**TOWN PLAN AND ZONING COMMISSION
TOWN OF WOODBRIDGE**
11 MEETINGHOUSE LANE
WOODBRIDGE, CONNECTICUT 06525

MEMORANDUM

Subject: Comprehensive Application Review- 804 Fountain Street

Project	Special Exception for construction of 96-unit multi-family dwelling complex
Location	804 Fountain Street (MBL:2604-690-804)
Applicant	Angelo Melisi
Contact	Attorney John Knuff
Owner	Fountain Street Associates, LLC

Figure 3: Proposed Site Layout.

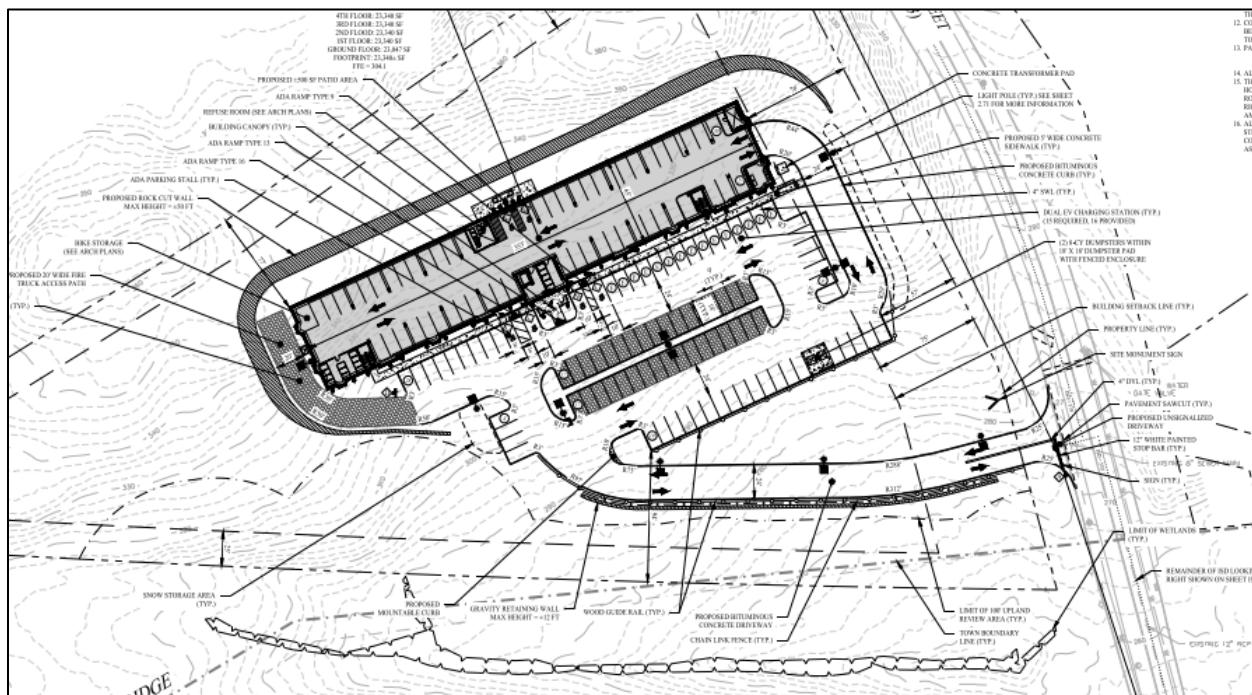
The location of the landscaping buffer along Fountain St and the driveway entrance should be reviewed. Moving the proposed landscaping further from the parking area will provide additional space to accommodate snow storage/plowing operations
